Clause 85 linear fit error

Adam Healey
LSI Corporation
September 2011

Linear fit pulse with increasing $c(-1)$

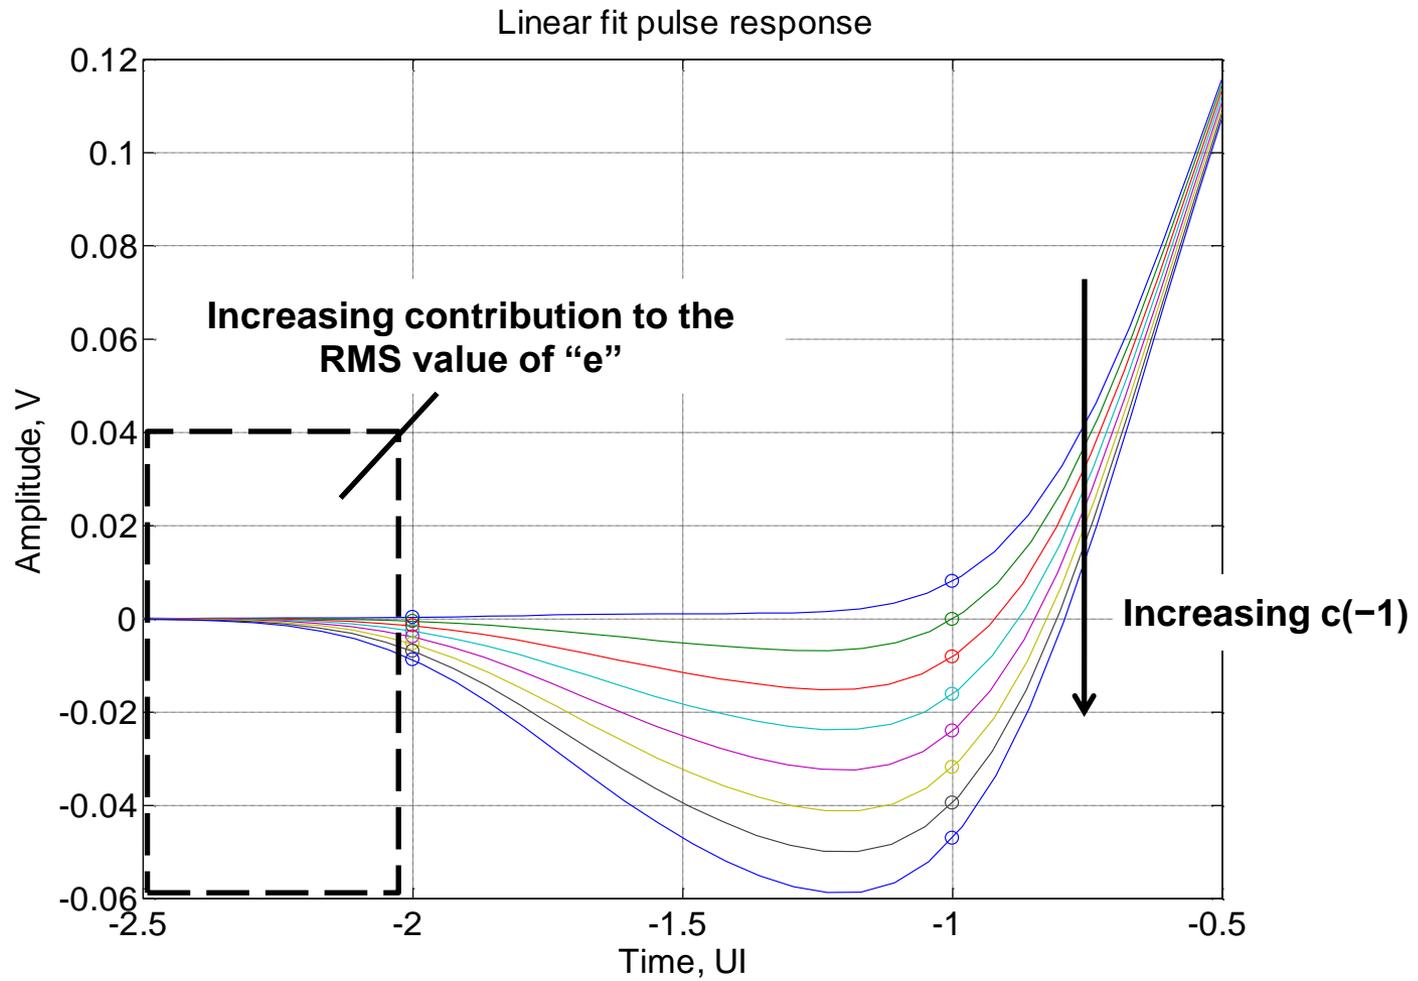
- 85.8.3.3 requires that the RMS value of the linear fit error, e , be less than the specified value (0.037) for each configuration of the transmit equalizer
 - P802d3REV_D2p0_section6.pdf, page 185, line 52
- Linear fit pulse values in the range $[-D_p, N_p - D_p - 1)$ unit intervals are excluded from linear fit error calculations
 - $D_p = 1$, $N_p = 7$ per Table 85-6
- Decreasing $c(-1)$ values (negative quantity) yield increasing “pre-shoot” in the linear fit pulse
 - Much of this pre-shoot occurs outside of the exception window defined by Table 85-6
- This pre-shoot incorrectly influences the linear fit error measurement
 - This may be remedied by changing the D_p and N_p values

Change D_p from 1 to 2

- In Table 85-6, change D_p to 2 and N_p to 8

Linear fit error with increasing $c(-1)$

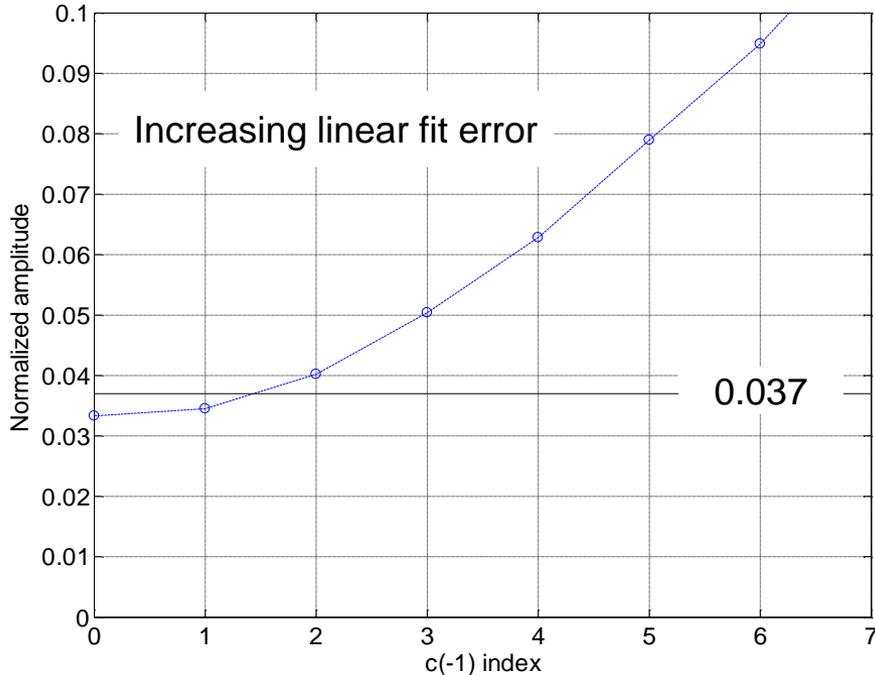
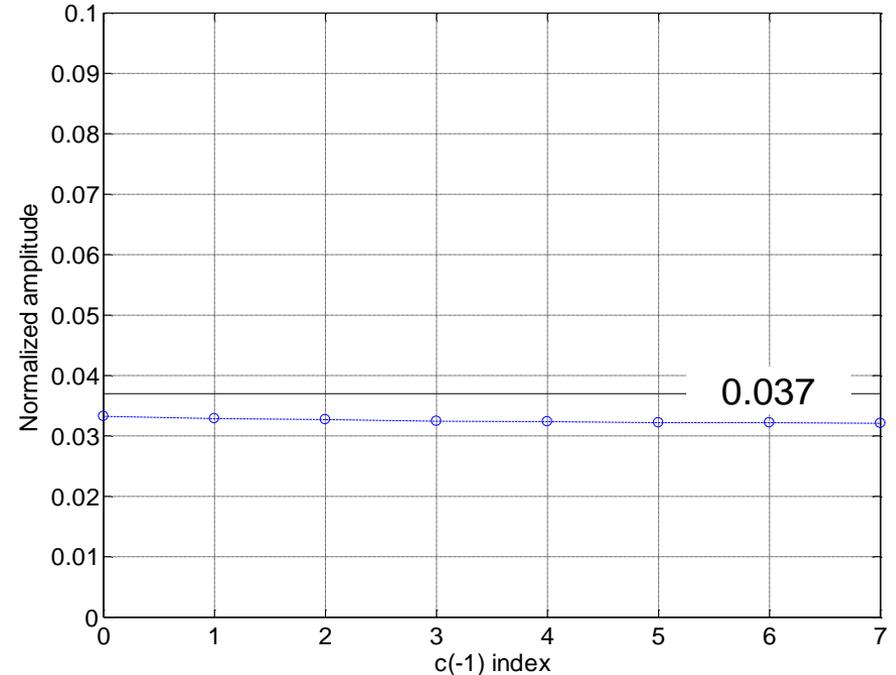
Linear fit error: $D_p = 1, N_p = 7$

Linear fit error: $D_p = 2, N_p = 8$

- Linear fit error limit may be fairly applied across all equalizer settings with a minor change to the D_p and N_p values
